Office Action Summary

08/464,034

HYATT, GILBERT P.

Office Action Figure A – Diagram of the Example Claim

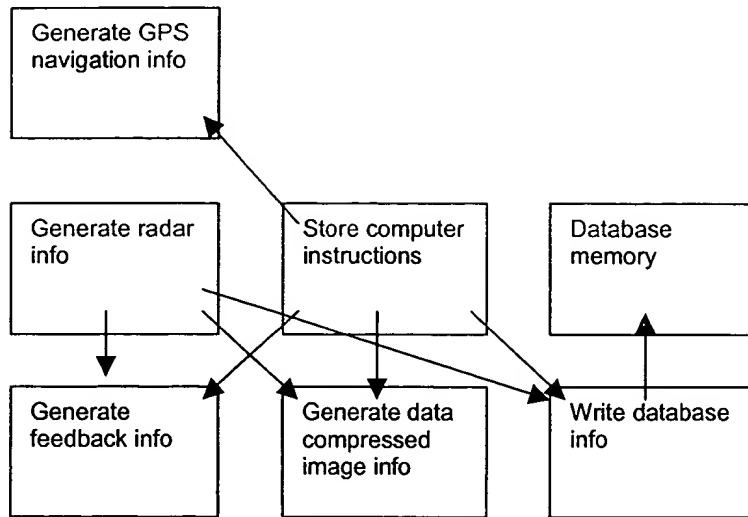
To begin with, and regarding the example claim, the examiner has diagrammed the claimed elements along with their interrelations in figure A below. The individual elements are depicted as boxes, and the interrelations are depicted as arrows spanning the boxes (i.e., not unlike the applicant's block diagram format; e.g., figure 1A).

There are no drawings that even remotely depict such a system. Neither the combination individual elements nor the interrelations between the elements are depicted anywhere. For example, according to the original specification, applicant's figures 1A and 1C depict the disclosed invention in block diagram form. That is, page 5 of the applicant's specification page describes these figures as follows:

Office Action Figure A1 – Applicant's Figure 1A

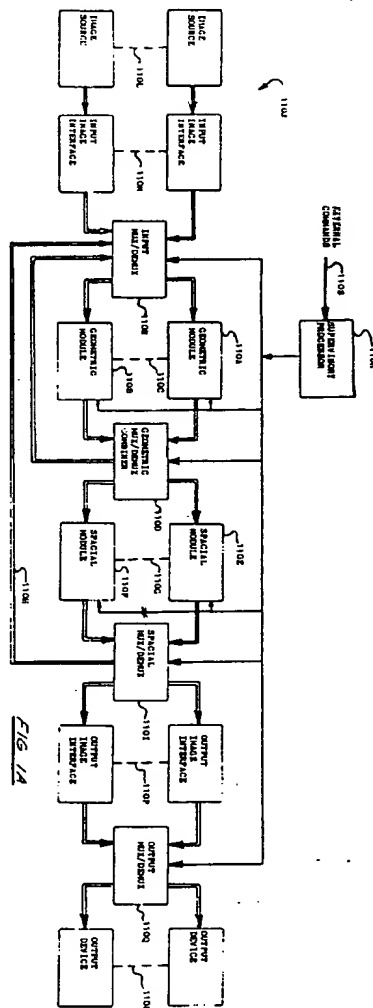
However, the applicant's figure 1A is merely a generalized, non-specific block diagram of a "system" that in no way depicts the combination of specific claimed elements, let alone the specific interrelations defined by the example claim. For

example, where in the applicant's figure 1A are the individual elements of the example claim (i.e., refer to the Office Action figure A above)? Further, where are the interrelations between the individual elements depicted? Where in the applicant's figure 1A, 1C or in any other figure is a depiction the aforementioned *combination of elements*, let alone the aforementioned *interrelations between the elements*? Upon a thorough examination of each and every figure of the applicant's original disclosure, **such** a figure cannot be found.

Office Action Figure C1 – Excerpt of Applicant's Figure 1A showing "image source"

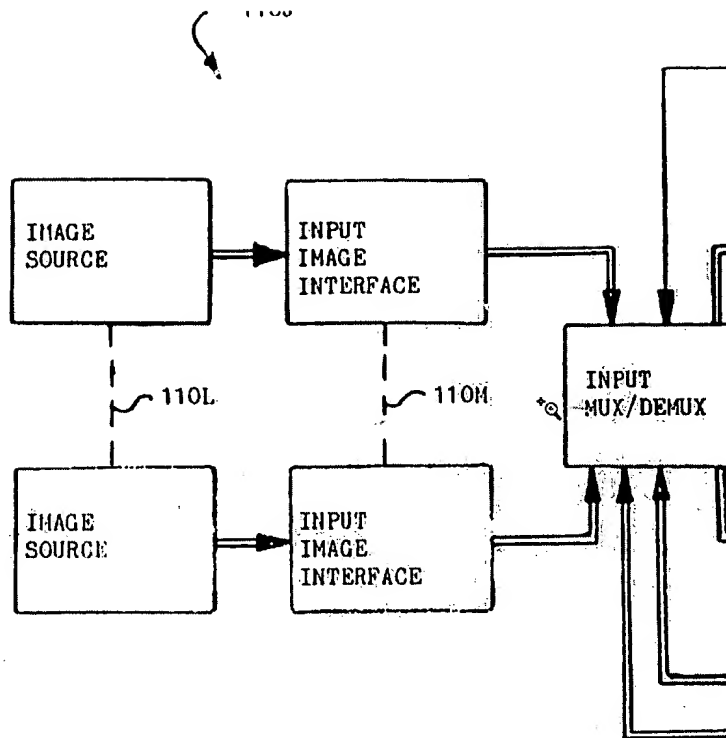
For example, the applicant's figure 1A depicts input image sources at numerals 110L, as follows:

However, there is no description either in the drawing or in the specification as to the nature of the interface between the image sources and the actual image processing circuitry. While modules 110M of applicant's figure 1A are labeled as input image interfaces, the nature of the signals input thereto, or output therefrom are not described. The specification is completely silent as to the nature of the signals, let alone any timing, synchronization or control.

Office Action Figure D – Applicant's Figure 5A

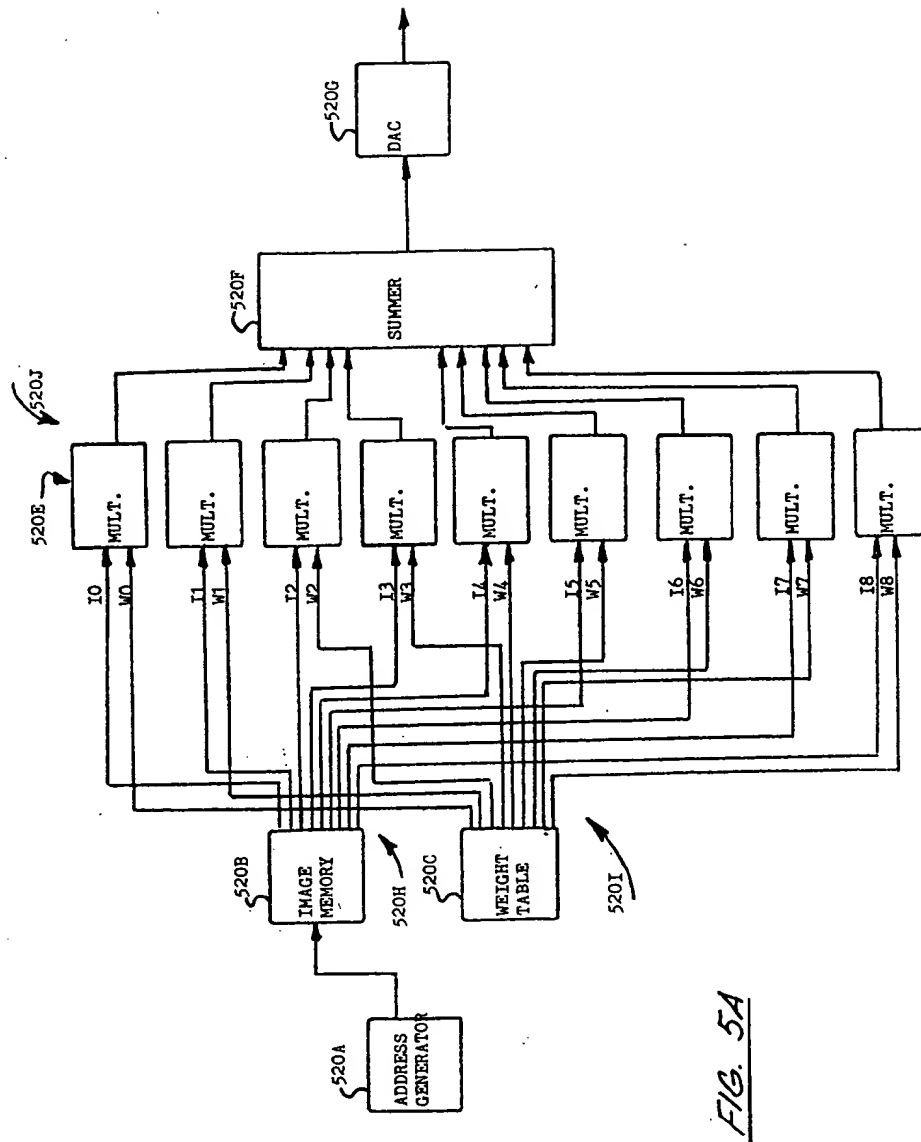
The applicant's disclosure on the other hand fails to describe the nature of any of the signals exchanged between circuits, any synchronization whatsoever, how those signals are derived, and how they are used in subsequent processing as fully described above. In order to further exemplify this, the examiner points to the applicant's figure 5A, which is similar to the figures of Billing, as follows:

Figure 5A depicts an “address generator” block connected to an “image memory”, which is connected to various multipliers, a summer and a DAC. Figure 5A also depicts a

"weight table" connected to the multipliers. However, the description ends there. In stark contrast to Billing, the applicant's figure 5A does not describe the function of the address generator, the nature of the signals emanating from the address generator, how it controls the "image memory", or how the "weight table" and the "image memory" are used in the subsequent multiplications, etc. Specification pages 161-163 which describe this figure completely fail to remedy this deficiency. Nothing in these pages describes anything related to the signal format and/or synchronization between the blocks of figure 5A. Little to no guidance is provided to enable one skilled in the art to make and use the invention without undue experimentation. While this is just one example, a similar analysis of any of the applicant's figures and corresponding portions of the specification reveals the exact same deficiencies.
